Ref 19.38

Garage Re-design Osborne House Monk Bretton - Planning Application Ref: 2021/1192

The following additional information addresses the concerns with regard to the use of photovoltaic panels on the roof of the proposed garages.

Fig 01. Panels installed in similar blue slate roof.

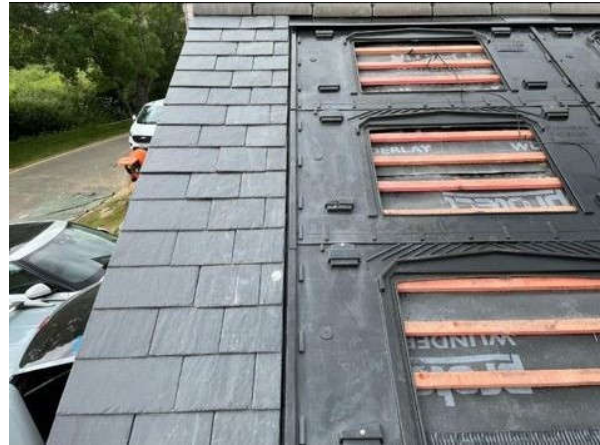
We note the Conservation Officers Appraisal where he supports the change of design of the garages but raises a minor concern with regard to the photovoltaic panels.

The images that follow show installation of the proposed pv at different stages to show how the GSE Integration in-roof mounting system would look when installed. As opposed to an above roof mounting system – the GSE becomes the roof covering instead of the tiles or slates and is mounted directly after the tiles and felt are installed. The remainder of the roof is then finished with the desired covering to leave a fully watertight roof covering. This allows the use of renewable energy in a manner that avoids the need for more intrusive over-roof panels which stand up around 150-200mm above the roof line.
